## Process Sheet

Customer	CU-DAR001 Dart Helicopters Services			Drawing Name	BRACKET	
Job Number	32661-1			Part Number	D35921	
Estimate Number	12811			Drawing Number	D3592 REV A	
P.O. Number	:			Project Number	NA	
This Issue	5/25/2007	S.O. No.	:	Drawing Revision	REV A	
Prsh Rev.	NC			Material	:	
First Issue	11	Type	SMALL /MED FAB	Due Date	6/10/2007	Qty: 125 Um: Each
Previous Run	32003					
Written By	<i>207-05-28</i>					
Checked & Approved By						
Comment	Est Rev:A	New Issue	07-03-26	ec

**From:** Daniel Campbell [dcampbell@dartaero.com]  
**Sent:** Thursday, May 31, 2007 9:41 AM  
**To:** 'Beckett, Bill'; Bedford, Sue; 'Bell, Christopher'; Campbell, Daniel; 'Charbonneau, Eric'; 'Elsliger, Leanne'; 'Fuentes, Roberto'; Golden, Brigitte; 'Johnston, Kim'; 'Lacelle, Linda'; mbellavance@dartaero.com; 'Menard, Jean-Luc'; 'Murdoch, Jason'; phum@dartaero.com; 'Provencal, Chris'; 'Sheldon, Susanne'; 'Shepherd, David'; 'Stow, Dan'; 'Trepanier, Dale'; Willems, Sian  
**Subject:** D3592-1 REV. A – UNDER REVIEW –

DESIGN <i>9P</i>	DRAWN BY <i>DC</i>	DART AEROSPACE LTD HAWKESBURY, ONTARIO, CANADA	
CHECKED	APPROVED	DRAWING NO. D3592	<i>Ra. B</i> REV. A SHEET 1 OF 1
DATE 07.01.15		TITLE PLATE	S

D3592-1 PLATE

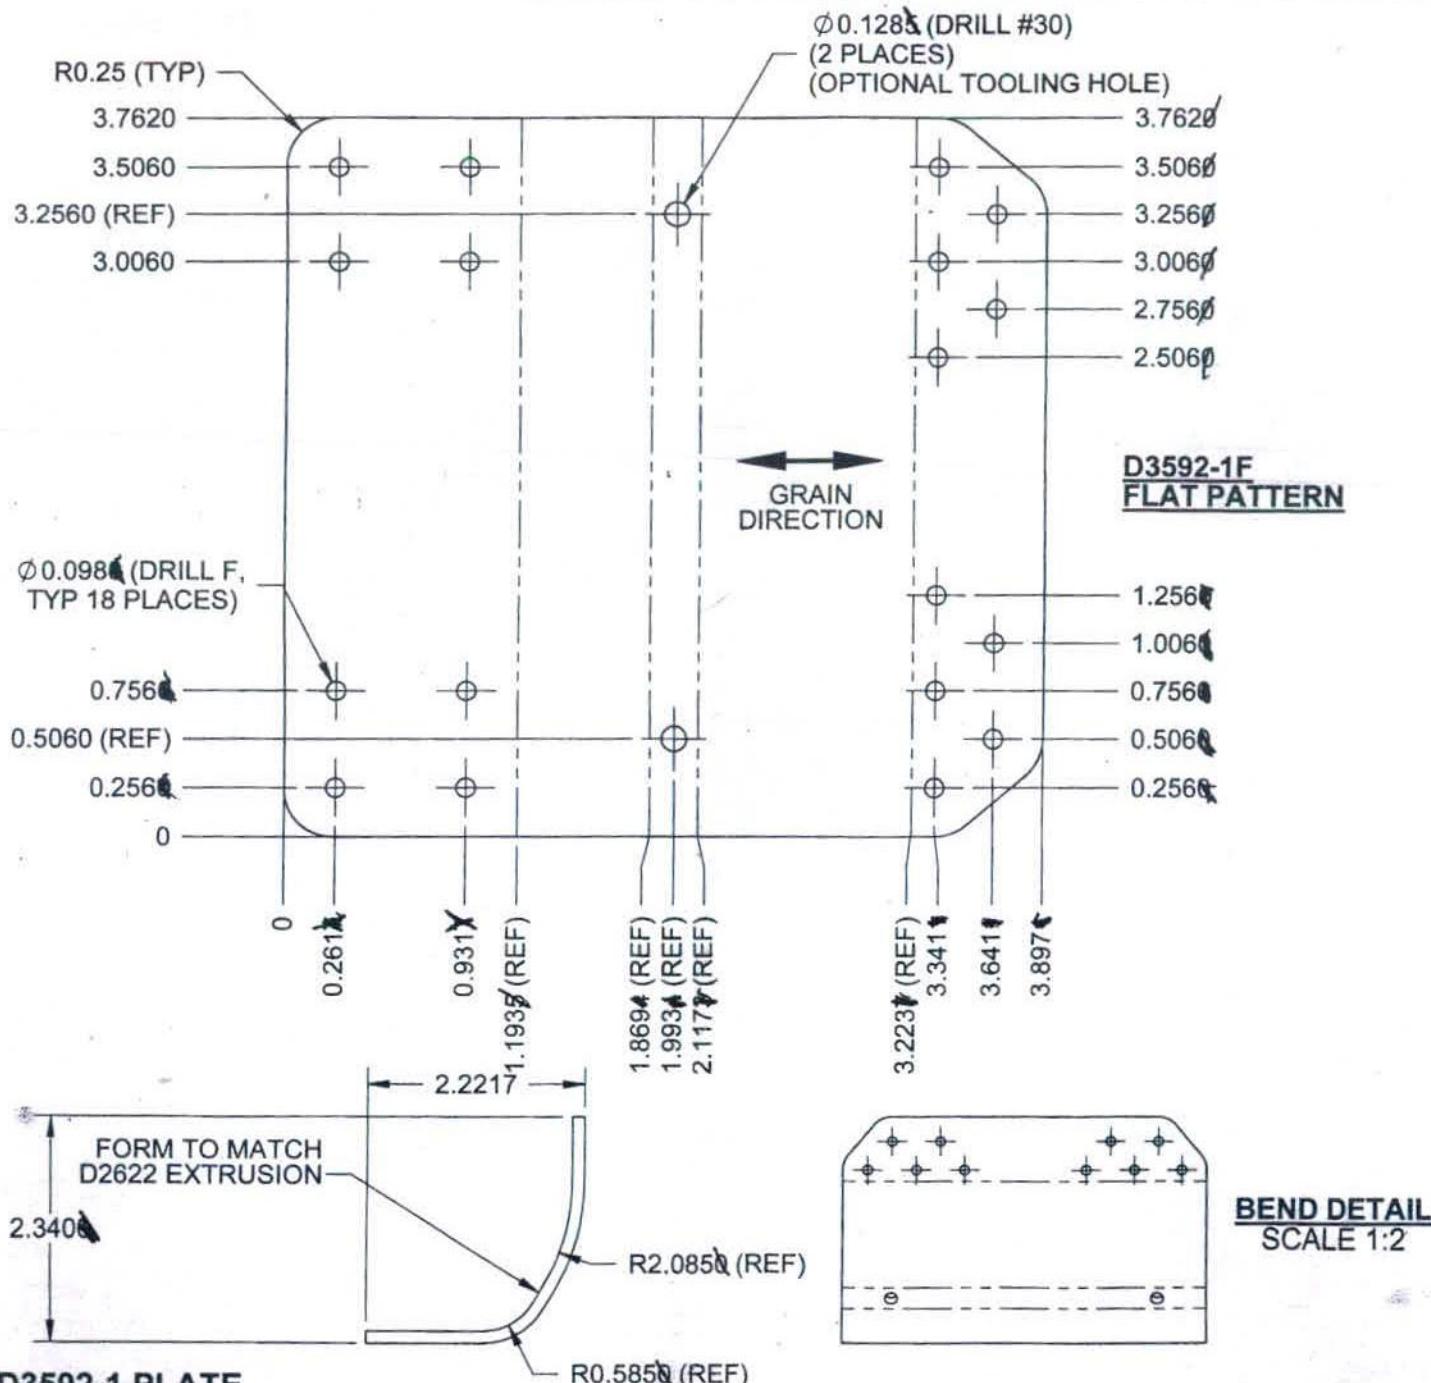
W/O:		WORK ORDER CHANGES					Approval Chief Eng / Prod Mgr		Approval QC Inspector		
DATE	STEP	PROCEDURE CHANGE			By	Date	Qty				
07/06/05	2	REPROGRAM TO REV.B TO ADD TOLING HOLES. SIZE ATTACHED AS EMAIL FOR OK ON TOLING HOLES						<i>GP</i> 07/06/05			
07/06/05	5	Split w/o			SB	07/06/05	85	<i>J</i> 07/06/12			
07/06/05	5	Split w/o			SB	07/06/12	42	<i>J</i> 07/06/12

DATE	STEP	Description of NC Section A	Corrective Action Section B			Verification Section C	Approval Chief Eng	Approval QC Inspector
			Initial Chief Eng	Action Description Chief Eng	Sign & Date			
07/06/04	2.0	125 parts scrapp. Parts needed extra holes for the bending tool.	GP 07/06/04 p/r	SCRAPP parts, and replace to Rev. B, under Preliminary Issue. See E-mail	W 01/06/04	J 07/06/04	GP 07/06/04 p/r	J 07/06/04
			QS1042	Scrap: destroy parts	SB 07/06/04	SB 07/06/04	QS1042

Essentially, the revision will consist of adding two 0.128 dia. tooling holes to assist in bending the part.
